NWB File: 2AM-DOH1335

Re: Response to Comments on the Submission of the Doris Pad U Contact Water Pond 60-day Notice under Water Licence 2AM-DOH1335

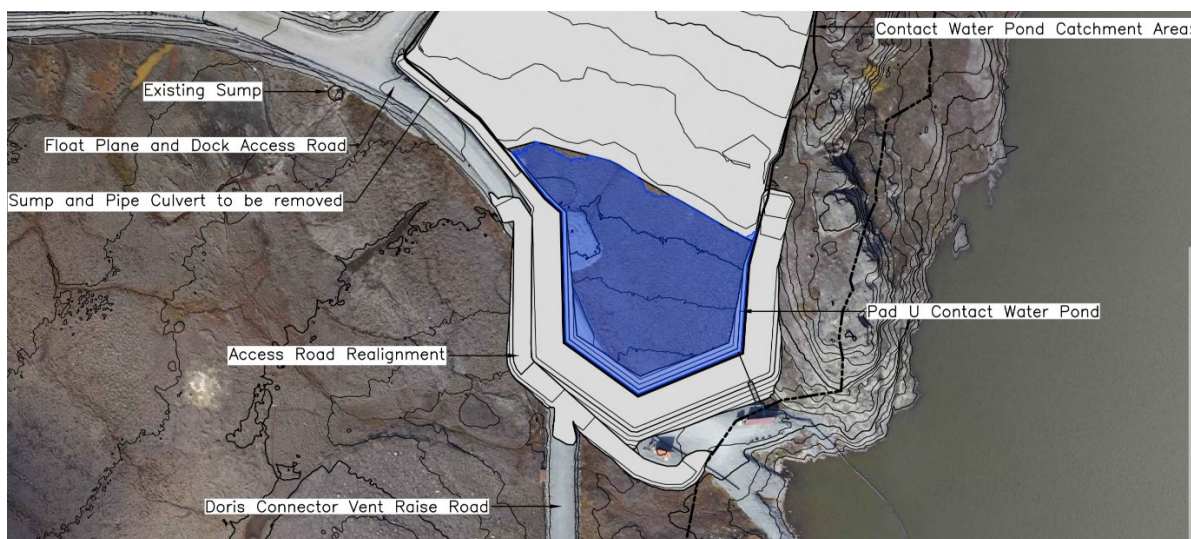
It is unclear how and where the dock access road will be and what measures will be implemented to ensure that no construction materials or other end up into nearby water bodies.

What is the concern is that construction materials and debris may end up in nearby water bodies.

CIRNAC recommends that the applicant clarify how and where this realigned dock access road will be implemented.

It is expected that a portion of the existing dock access road be realigned to outside the footprint of the CWP berm as shown on Attachment 1, Drawing No. 62-686-230-004 of Notice of construction – Pad U CWP memo. The realigned portion of the access road will tie back into the existing portion of the access road near the float plane dock access (see below).

The access road realignment work will be carried out in accordance with the Water Licence and established construction best practices. The following specific measures will be implemented to mitigate the impact of construction activities to the nearby water bodies:

- CWP berm construction and access road realignment will take place in winter, where no rain events or surface water flow can occur.
- The 31 m setback from the high-water mark of nearby water bodies will be respected. As shown on Attachment 1, Drawing No. 62-686-230-004 of Notice of construction – Pad U CWP memo, the access road realignment is outside the setback.
- Construction/environmental inspections and good site management practices to mitigate the risk of debris leaving the work area.

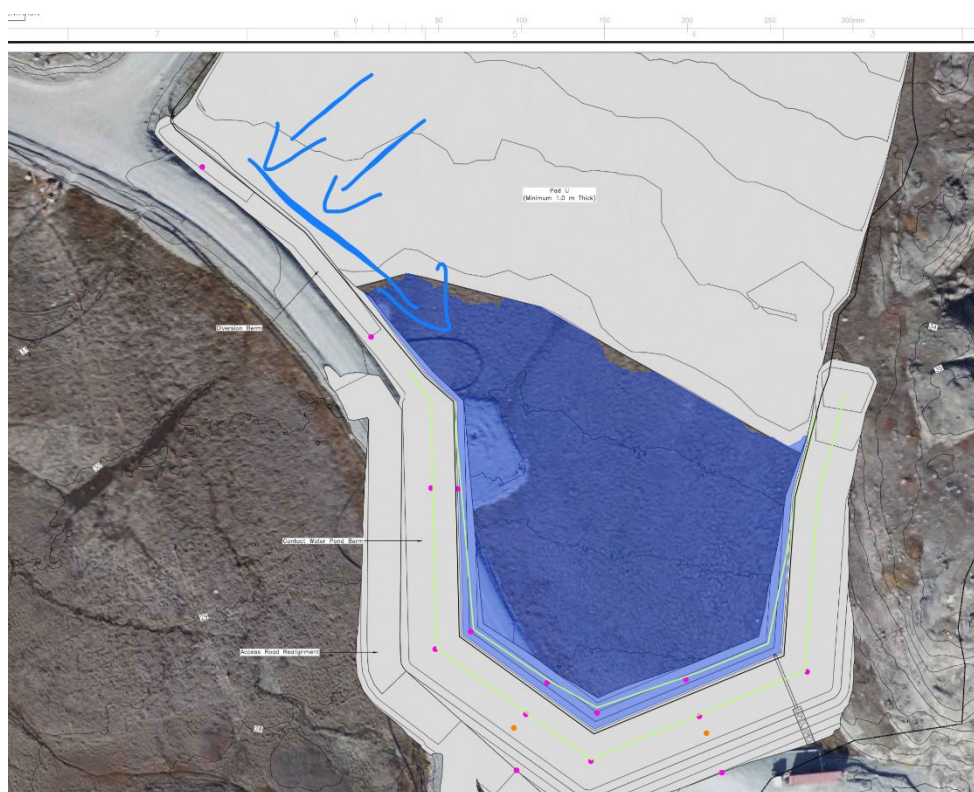
It is unclear what seepage water the downstream diversion berm is going to be diverting and where it will be diverting to. The concern is that contact water will not be captured.

CIRNAC recommends that the applicant provide further explanation as to how the diversion berms will function.

The downstream diversion berm (as shown in Attachment 1, Drawing No. 62-686-230-004 of Notice of construction – Pad U CWP memo) is designed to divert surface contact water from the east side of Pad U towards the CWP (see below).
